International Oriental Rug Façade Change JC13-176

Consideration of the request of International Oriental Rug for Preliminary Site Plan and Section 9 Façade Waiver. The subject property is located in Section 24 at 41360 W. Ten Mile Road on the north side of W. Ten Mile Road, east of Meadowbrook Road in the B-1, Local Business District. The applicant is proposing to modify the front façade of an existing vacant retail building by replacing the existing asphalt shingle fascia with new metal roof siding.

PLAN REVIEW CENTER REPORT

Re: FACADE ORDINANCE – Final Site Plan Review
International Oriental Rug, PSP13-0151

SHEET TITLE
 FRONT ELEVATION AND SECTION

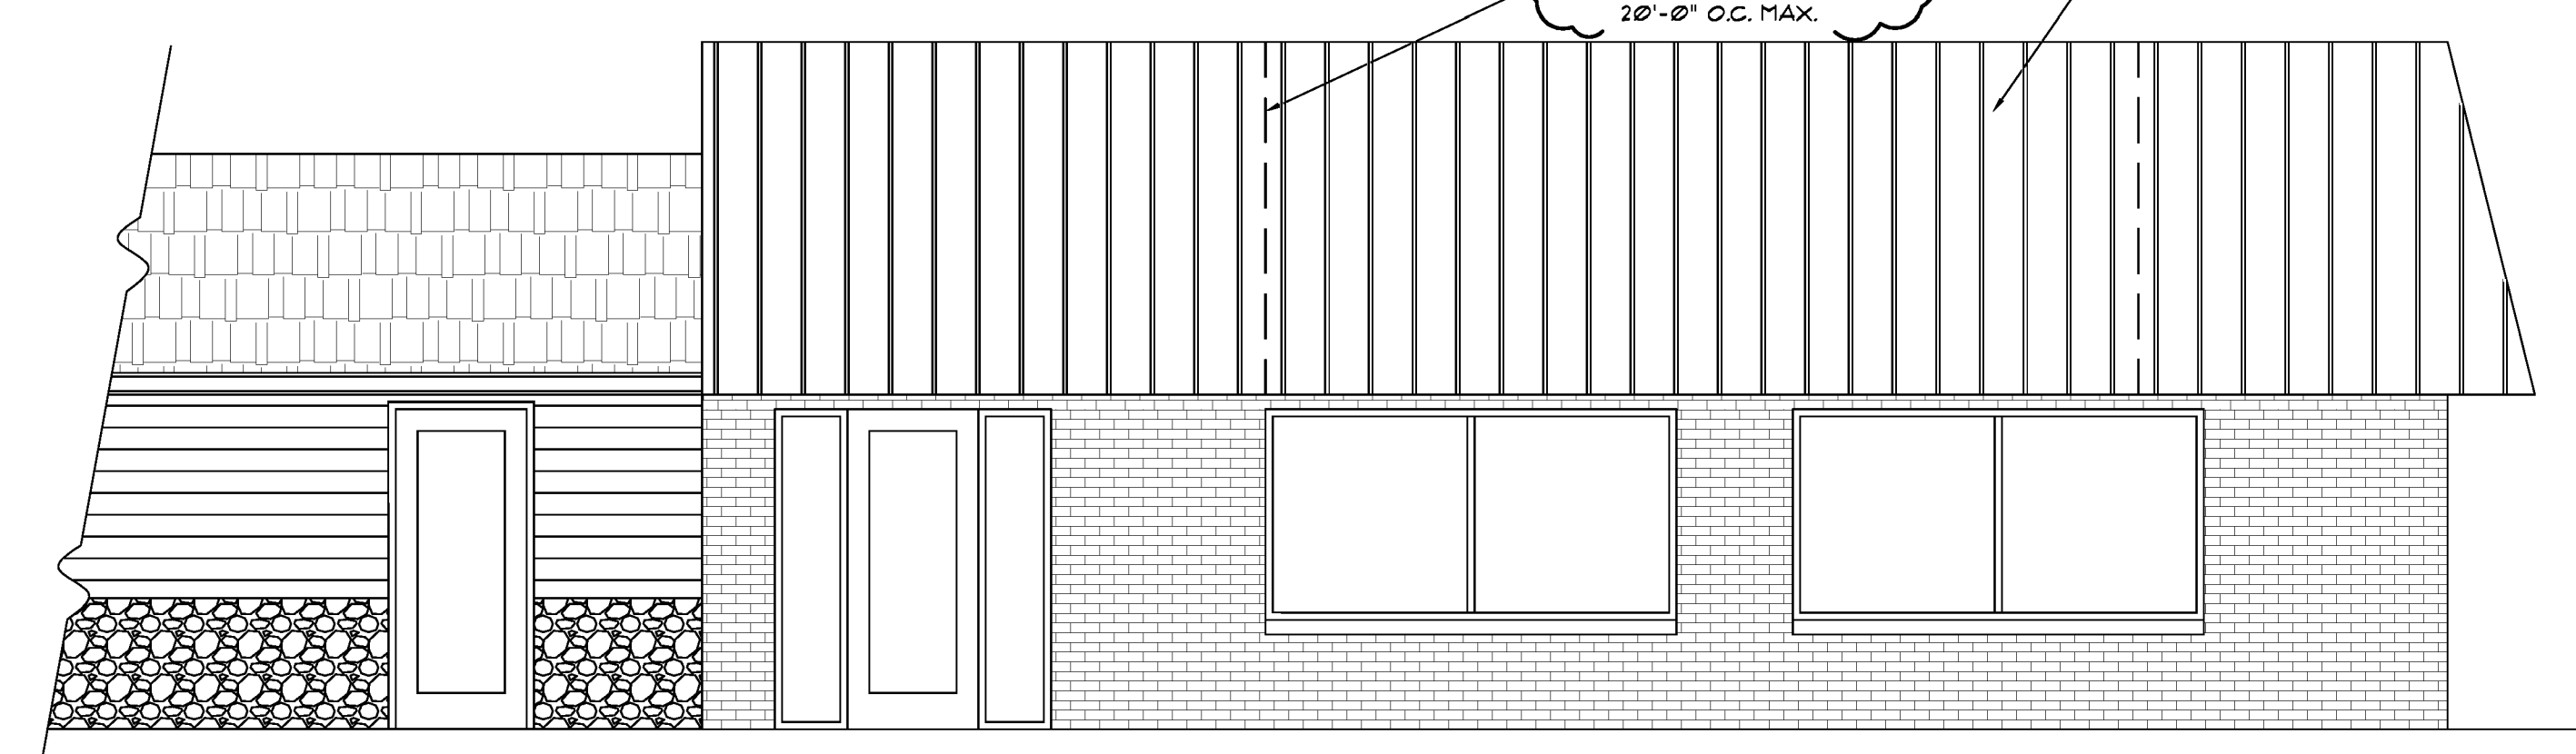
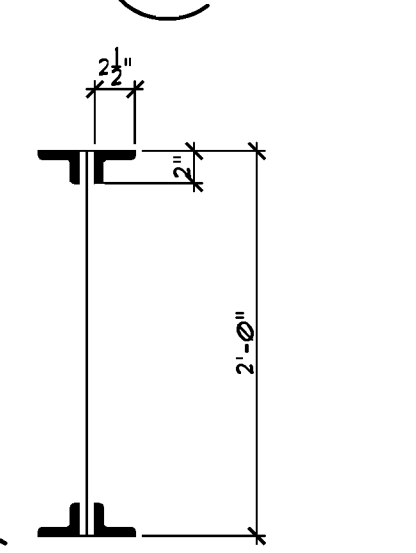
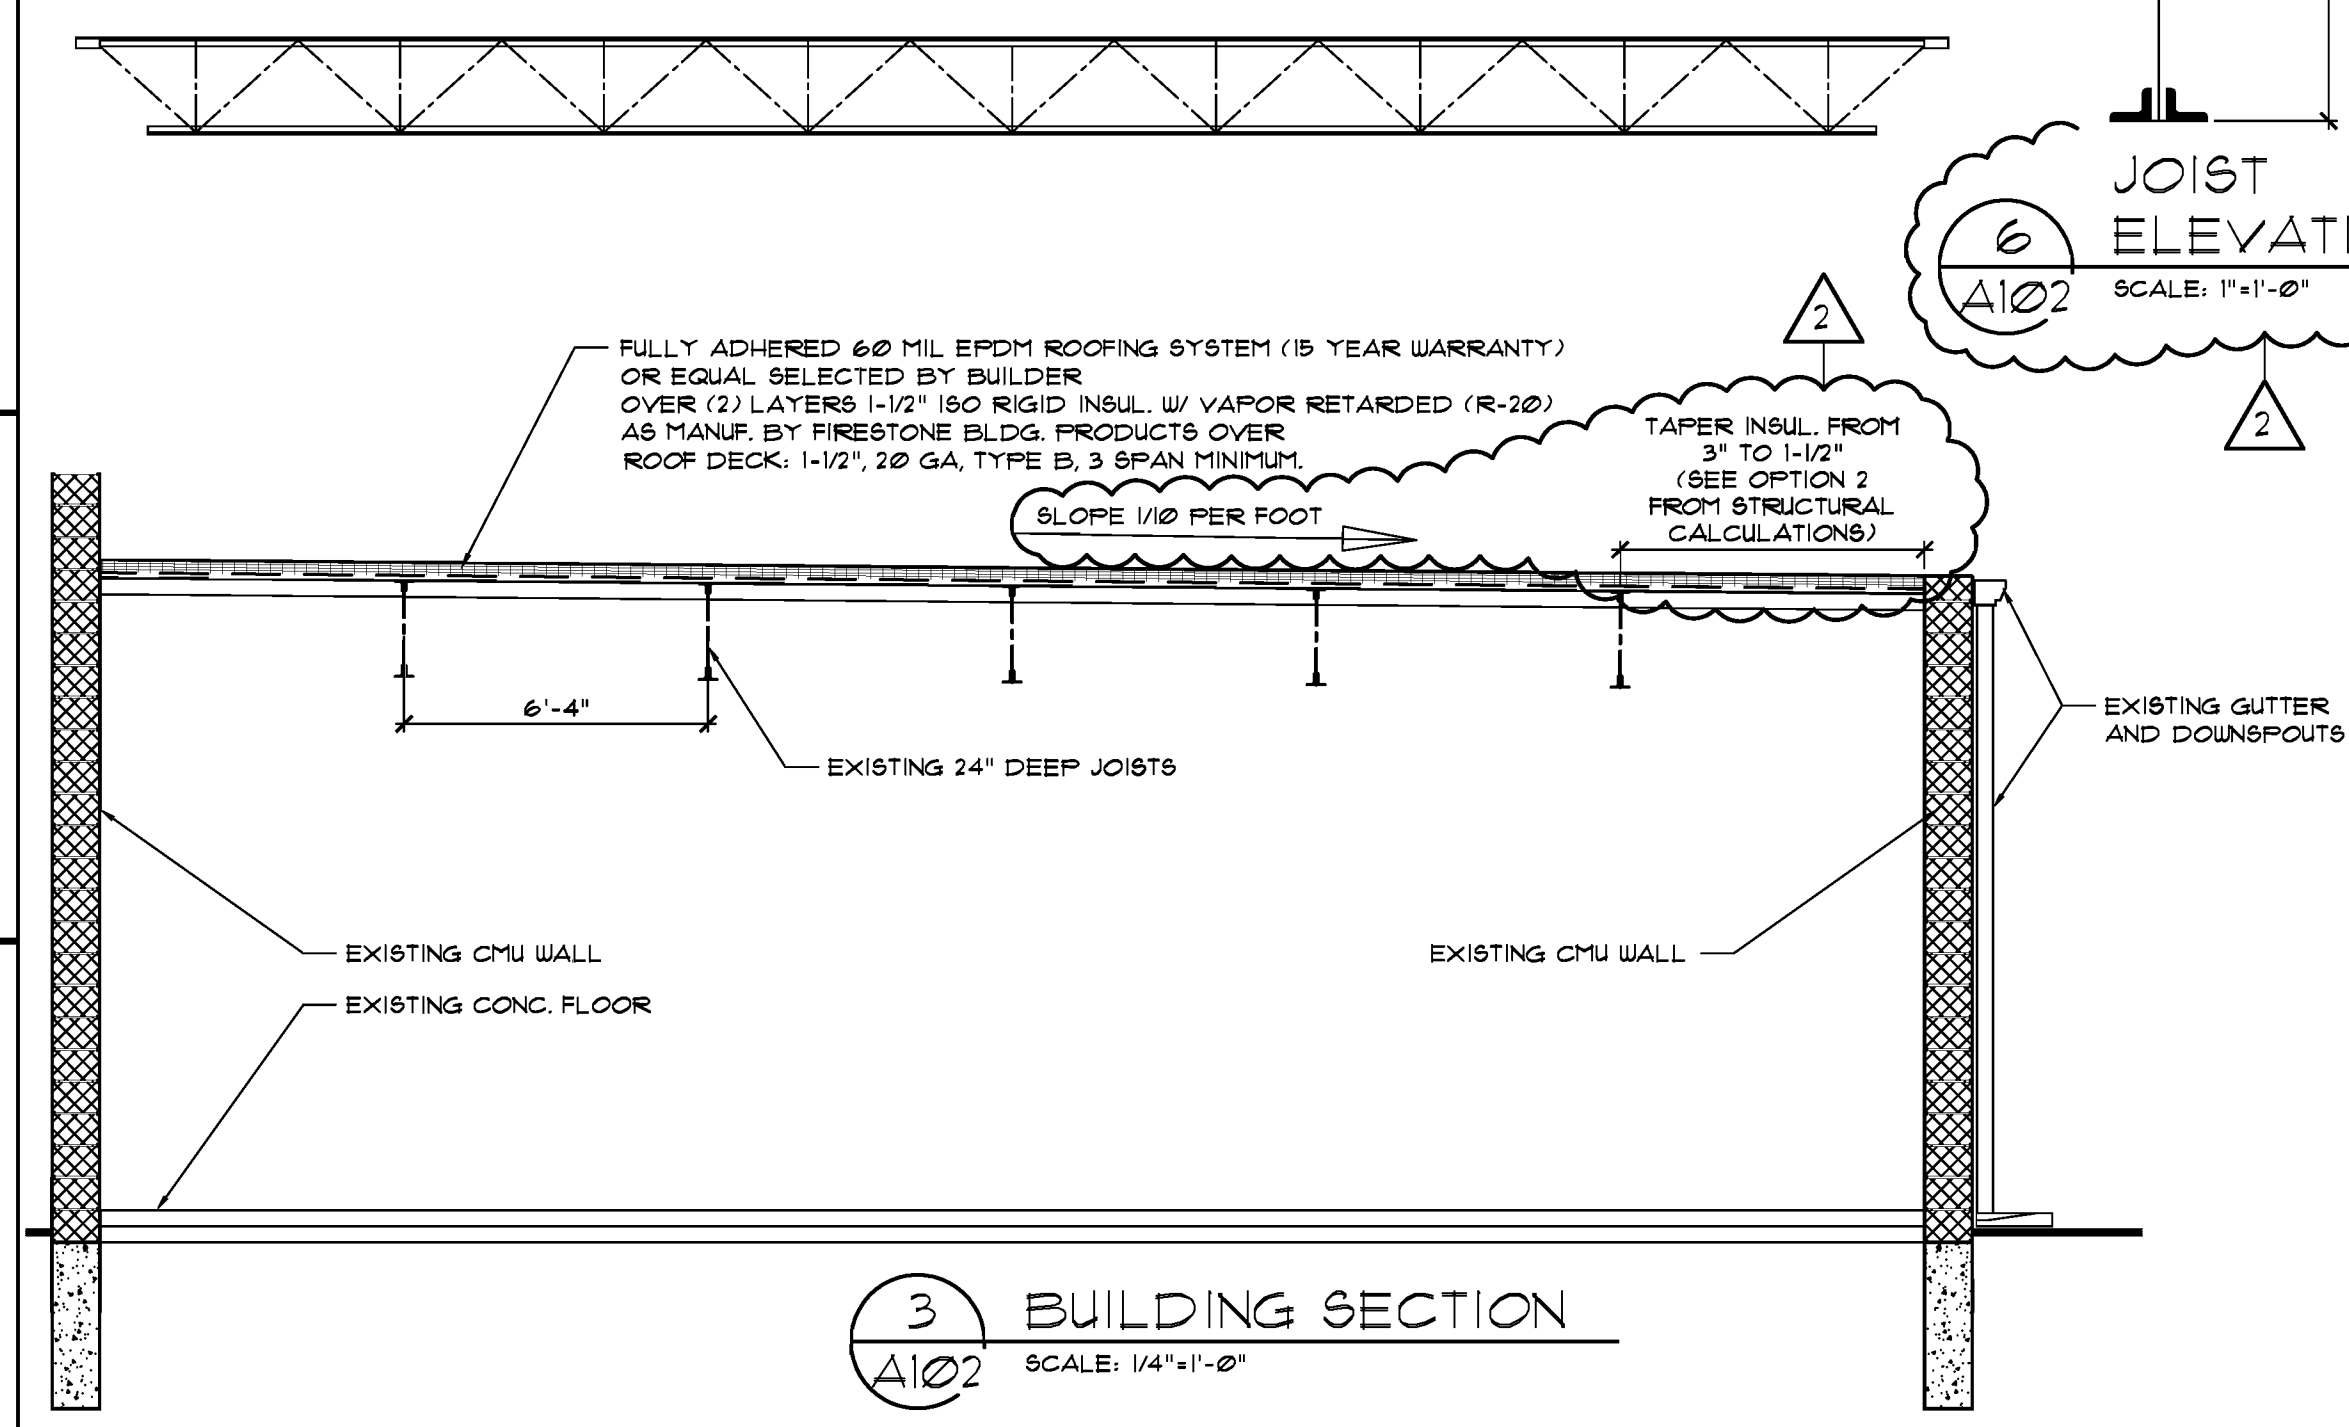
Façade Region	South (Front)	East	North	West	Ordinance Maximum (Minimum)
Brick	37%	Unaltered	NA	NA	100% (30% Min)
Standing Seam Metal	63%	Unaltered	NA	NA	25%
Painted CMU	0%	Unaltered	NA	NA	0%

This project consists of a façade alteration in accordance with Section 2520.6 of the Façade Ordinance. The project consists of replacing the existing asphalt shingle fascia with a new “metal roof siding”. No sample board was provided for the proposed material. Based on the drawings provided, it is assumed that the proposed material is equivalent to Standing Seam Metal with standing seams spaced at 12” on center. As shown above the proposed amount of Standing Seam Metal exceeds the maximum amounts allowed by the Façade Ordinance on the south facade. A Section 9 Waiver is required for this deviation from the Ordinance.

Although the proposed materials deviate significantly from the Façade Chart, the proposed alteration represents a significant enhancement in the building’s façade. A Section 9 Waiver is therefore recommended for the overage of Standing Seam Metal. This recommendation is contingent on the applicant providing a sample of the “metal roof siding” indicating the precise color and profile of the proposed material, at least 5 days prior to the Planning Commission meeting. It should be noted that ribbed metal siding is not allowed in Façade Region 1.

- 1) We have provided a waiver request for the overage of the proposed metal roof siding.
- 2) The owner will provide a sample of the proposed material.
